ASME Meeting with U.S. Nuclear Regulatory Commission

ASME Code Sections III & XI Risk-Informed Code Cases

Key N-660-2 Comments to be Addressed

Figure I-1
Risk-Informed Safety Classification Process

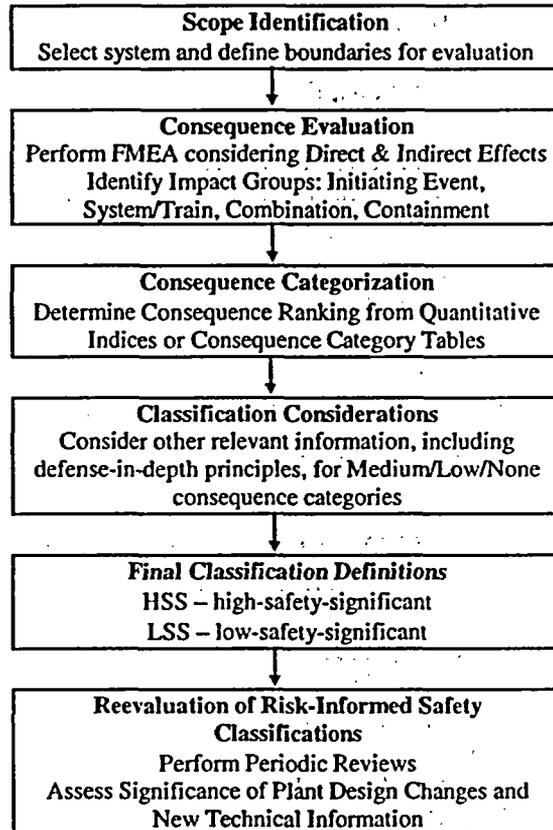
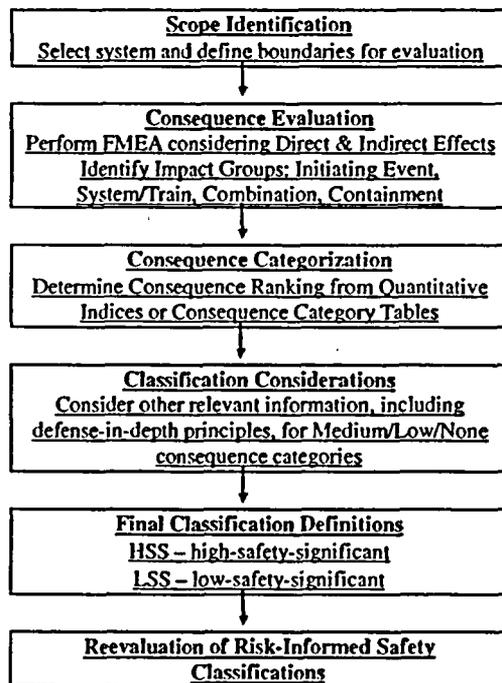
PAGE & PARAGRAPH REFERENCE	D/C	COMMENTS AND/OR RECOMMENDATIONS	DISPOSITION OF COMMENTS
Figure I-1		The RISC process steps are incomplete as shown in Figure I-1 and should be revised to include a final step identifying the requirement for Reevaluation of Risk-Informed Safety Classifications and the titles and numbering of the major Sections (e.g., I-2.0, I-3.0, I-4.0, etc.) should reflect what is in this Table and not mixed up as they are now and thus I-3.0 should be re-titled as CONSEQUENCE EVALUATION and I-3.1 should be "Analysis and Assessments," etc.	Change made to Figure I-1 and Section titles (I-3.0 and I-3.1).
I-2.0		I believe that this requirement would be much clearer if The following words were deleted from the beginning of the second sentence: "Items optionally classified to Class 1 and," and then just start the sentence as: "Class 1 items connected to the ...," and the reference to 10 CFR 50.55a (c)(2)(i) and (c)(2)(ii) will sufficiently cover the exceptions.	Change made to requirement in - 1200(b).
